APPROVED  
(Subject to Revisions)  
Inspection Department  
Lake City Fire Dept.  
State Fire Inspector  
License # 11287  
By: [Signature] Date: 9/23/06

A CUSTOM ADDITION FOR:  
**EVANGEL CHURCH OF GOD**  
PROJECT ADDRESS: PARCEL 112-AS-16-02940-002, SISTERS WELCOME RD, COLUMBIA COUNTY, FL 32025

SHEET NUMBER  
**A.1**  
OF 8 SHEETS

**FLOOR PLAN**  
SCALE: 1/4" = 1'-0"

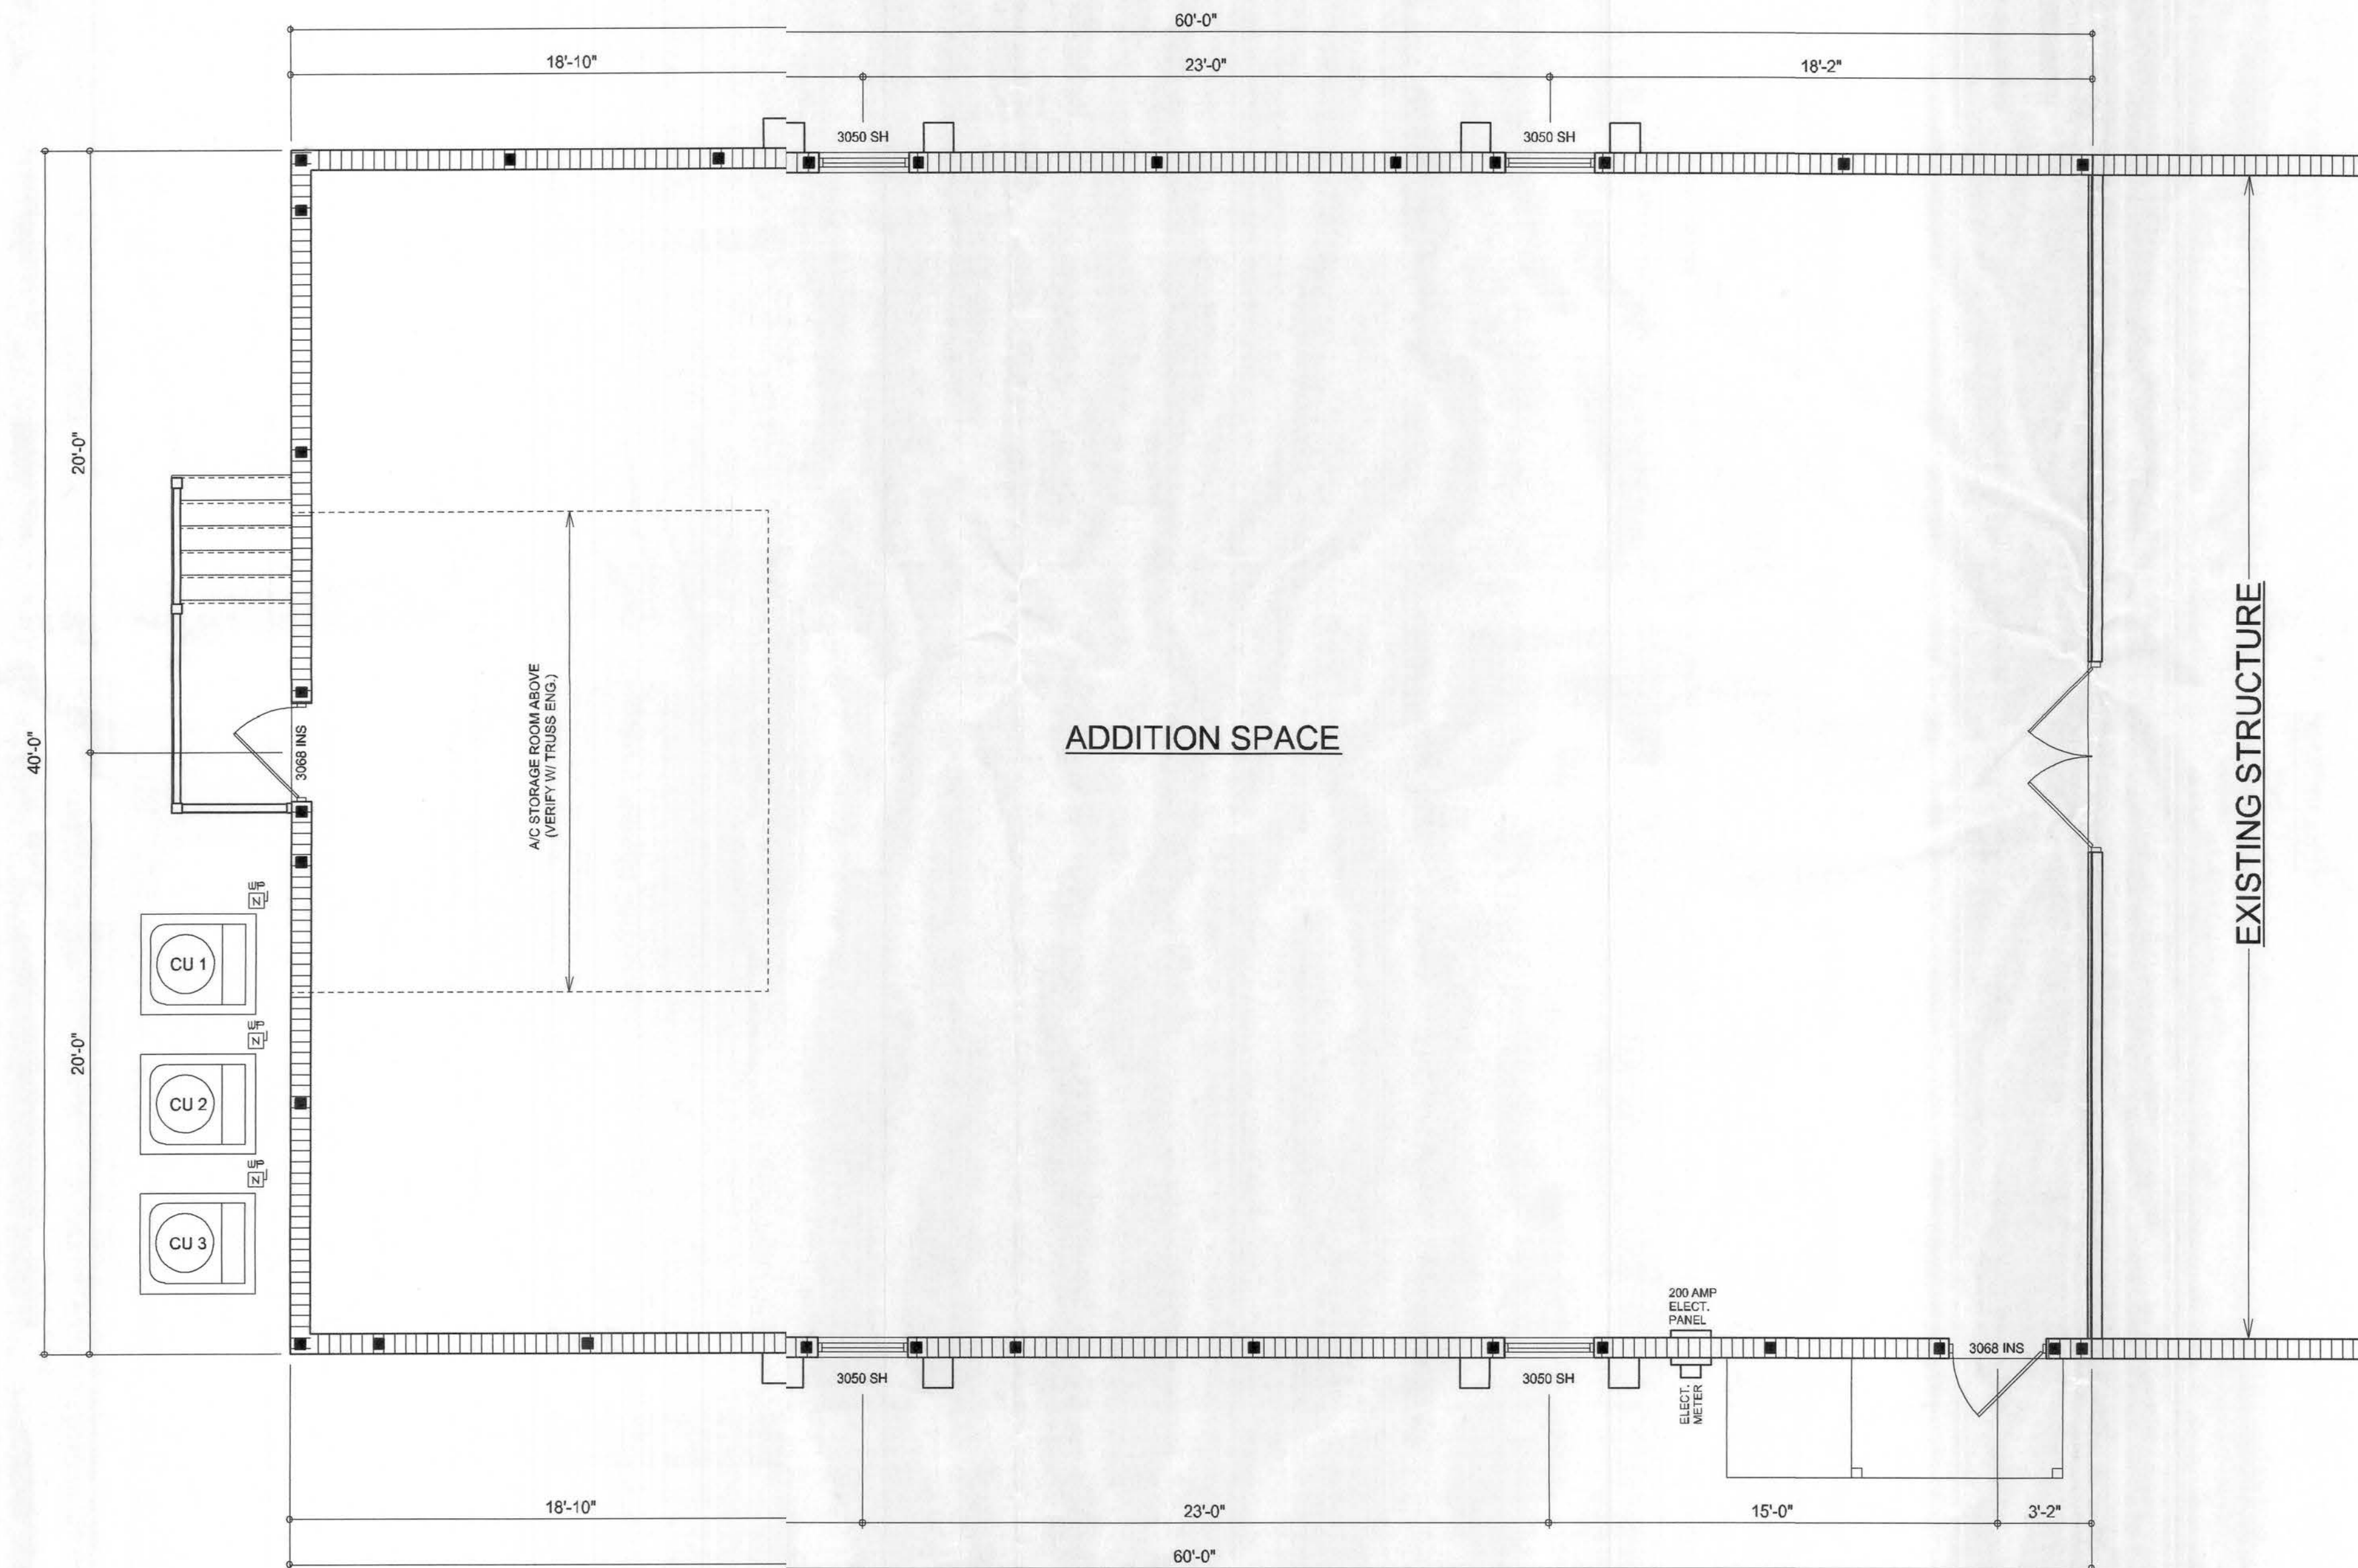
490  
Assembly  
standing space  
90' Express

VERIFY WINDOW SIZES WITH  
EXISTING.
